Technical Bulletin

Model
911C2/C4

Subject: Heater Fan Motor, Securing

Number
9001

Figure 1

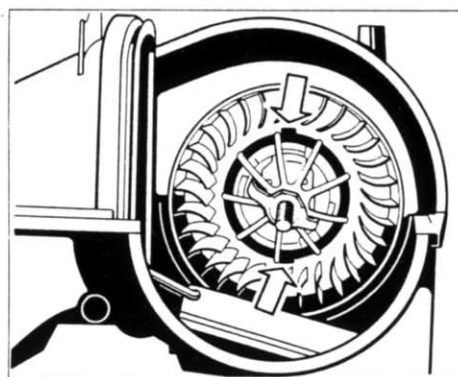
Repair Information: The heater fan motors are secured with two plastic screws each, in addition to the locking tabs, from production date October 1989. When removing the fan motors, the screws must be removed before disengaging the locking tabs. The screws can be accessed through openings in the blower wheel (arrows in Figure 1). Reinstall both screws after repairs. Refer to 911 Carrera 2/4 Workshop Manual Volume VI, page 87-13 thru 87-15 for heater fan motor removal and installation procedures.

Figure 2

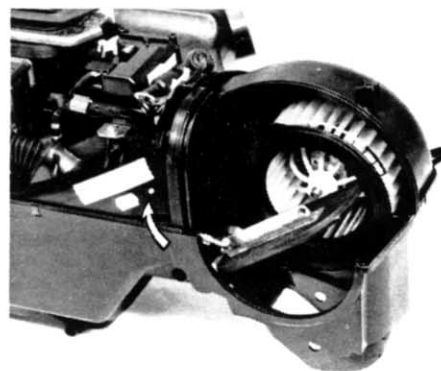
Fan motors with the additional securing screws can be identified by a white paint dot in the area of the manufacturers identification plate (arrow in Figure 2).
